UNITED STATES PATENT AND TRADEMARK OFFICE

APPLICATION NO.	FILING DATE	FIRST NAMED INVENTOR	ATTORNEY DOCKET NO.	CONFIRMATION NO.
10/559,965	08/21/2006	Gunter Weickert	067670-5009-US	6544

Office Action Summary	Application No. 10/559,965	Applicant(s) WEICKERT ET AL.	
	Examiner WILLIAM K. CHEUNG	Art Unit 1796

DETAILED ACTION

Applicants' invention is related to the reactor system as depicted in Figure 1 below.

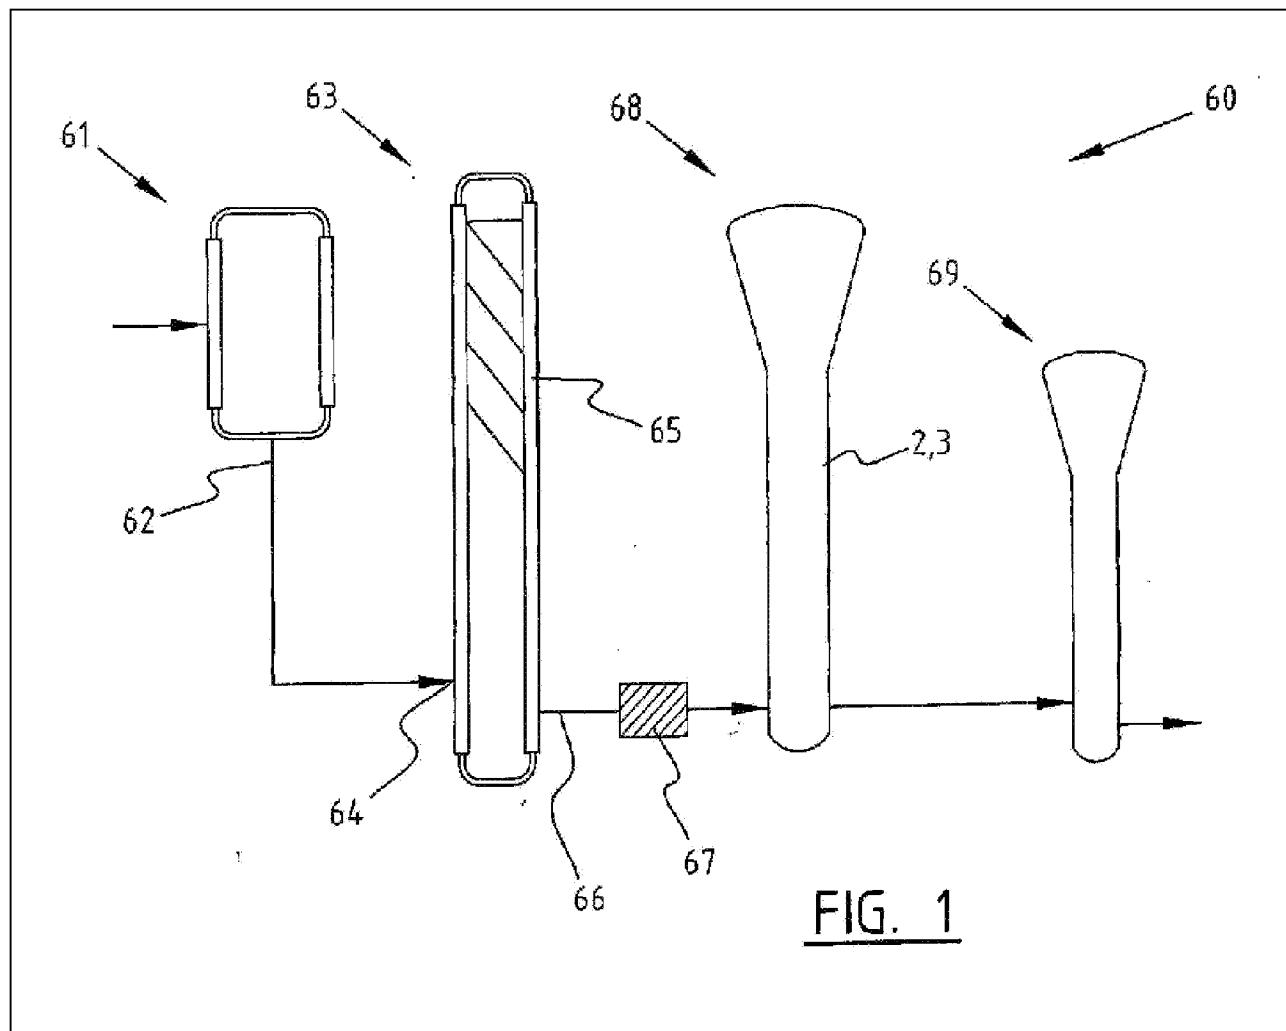
5. Regarding claim 27, the word "means" is preceded by the word(s) "flashing" in an attempt to use a "means" clause to recite a claim element as a means for performing a

specified function. However, since no function is specified by the word(s) preceding "means," it is impossible to determine the equivalents of the element, as required by 35 U.S.C. 112, sixth paragraph. See *Ex parte Klumb*, 159 USPQ 694 (Bd. App. 1967).

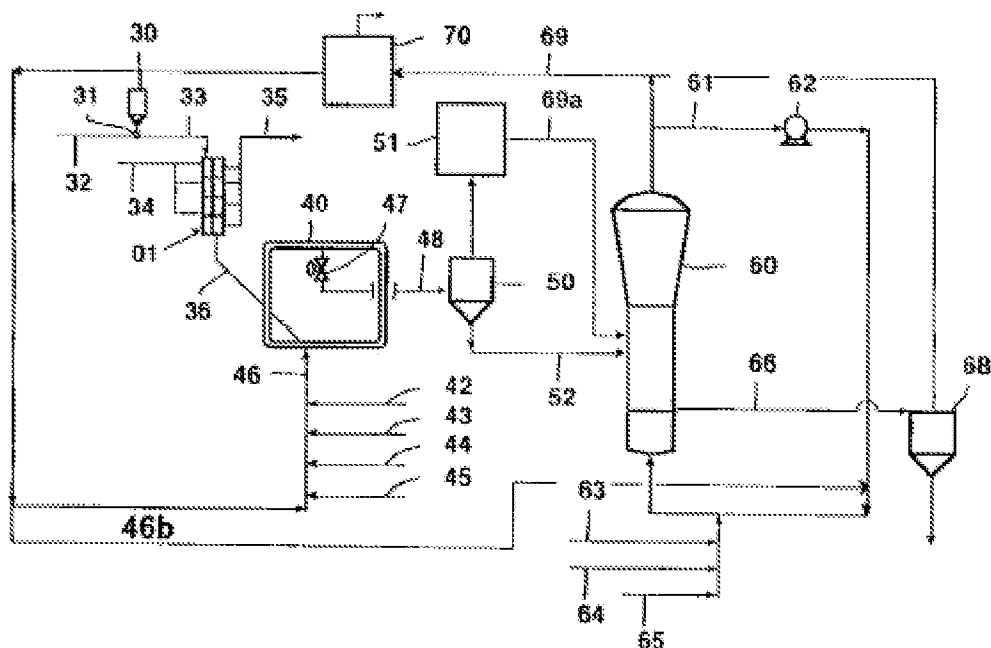
Harlin et al. (Figure 1) disclose a polymerization process for preparing polypropylene in a reactor system comprising pluralities of reactors. Harlin et al. (col. 11, line 17-48) clearly indicate that the polymerization process of Harlin et al. comprises a prepolymerization reactor (1), a first loop reactor (40), and a second gas phase (fluidized bed) reactor (60). Harlin et al. (col. 16, claim 24) clearly teach that a third gas phase reactor can be installed.

The difference between the invention as claimed and the process of Harlin et al. is that Harlin et al. do not teach process involving a second reactor comprising a moving bed under such conditions that the residence time in the fluidized bed and the residence time in the moving bed are independently controlled.
